ST/SG/AC.10/C.3/2008/47
14 April 2008

**MISCELLANEOUS PROPOSALS OF AMENDMENTS TO THE MODEL
REGULATIONS ON THE TRANSPORT OF DANGEROUS GOODS**

Protection of shell and service equipment on portable tanks

Transmitted by the expert from Australia*

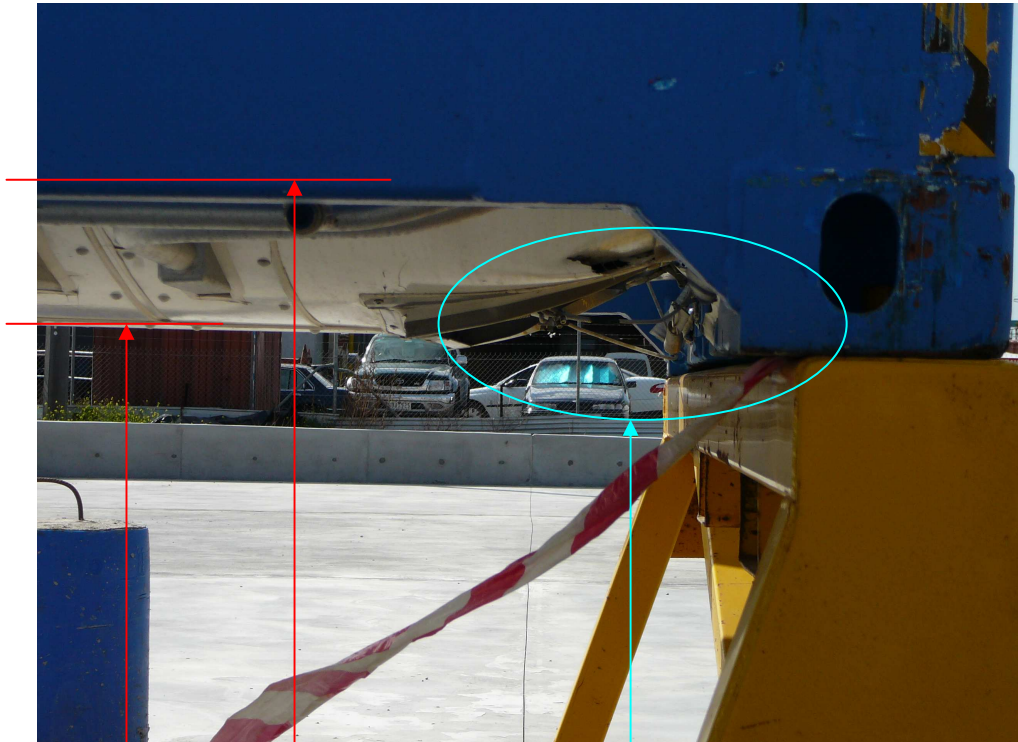
5. The design of the portable tank was such that the bottom of the valve structure, vent fittings and shell insulation all sat below the line of the longitudinal side rails. When the tank was landed without being properly aligned on the cradle, the load was taken by the bottom of the tank and valve (see photograph below). The same situation would occur if the tank had been landed on top of another container in the same manner, noting portable tanks are stacked in ship board stows and container terminals, so the risk is not isolated to the use of materials handling equipment such as pin cradles.

Bottom of the tank insulation
and the lower portion of valve

Longitudinal side rail

Area where the tank
landed on the pin cradle
Note: valve has been
removed

6. As a result of the landing, the insulation and vent lines were pushed up and a securing bracket on the vent lines was sheared. More seriously, the valve stem was pushed up and sheared off at the flange. The impact was also sufficient to displace the internal stop valve resulting in a slow leak of the contents from the tank. While compliance with section 6.7.2.6.3 should have prevented displacement of the foot valve, it appears the amount and type of damage to the valve stem may have made the leak inevitable. The level of protection of the valve stem was a major factor in this incident.
